Open issues

Kevin Daines
World Wide Packets

12 January 2005

P802.1AE/D2.02 Fig 11-6

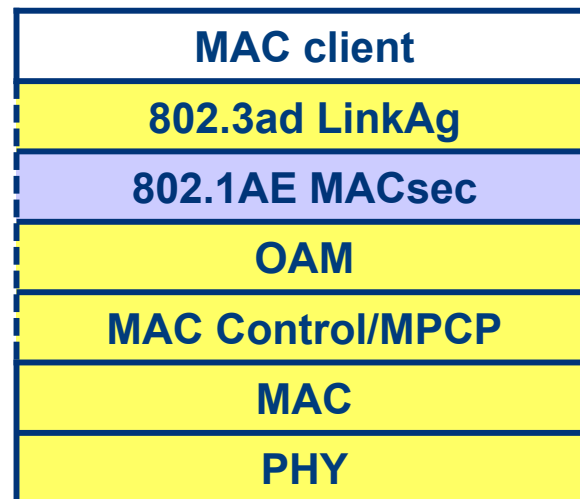
- P802.1AE/D2.02 shows SecY below the Link Aggregation sublayer

- OAMPDUs, MAC Control frames and MPCPDUs would **NOT** be encrypted while LACPDUs *would*
- Problems, concerns?

Figure 11-4—Frame format showing VLAN Tag

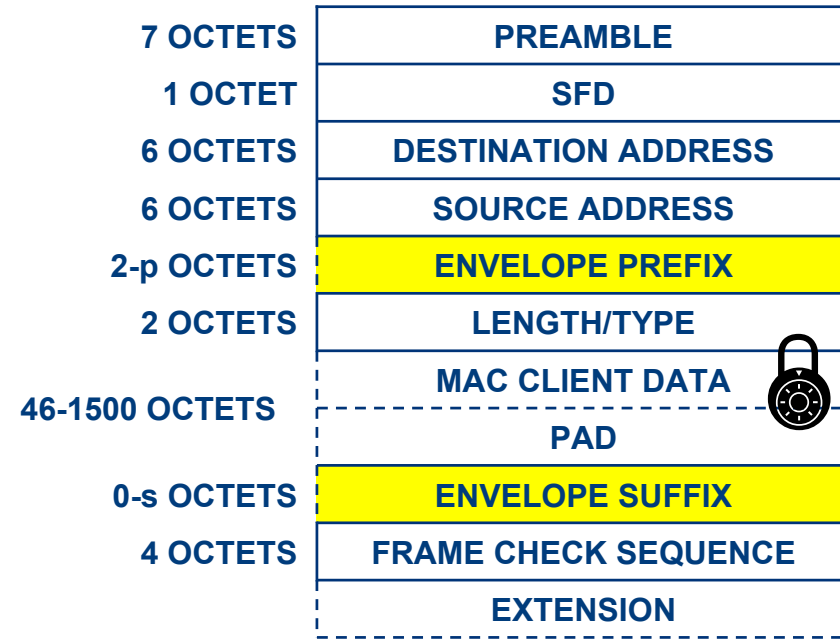
- A possible concern was raised in San Antonio about LinkAg flows for load-balancing
 - Often a flow is { DA, SA, Tag-12, Pri-3 }
- Does a VLAN Tag need to be the first tag in the Prefix field?
 - P802.1AE/D2.02 Figure 11-4 shows a VLAN Tag *after* the SecTag (below)
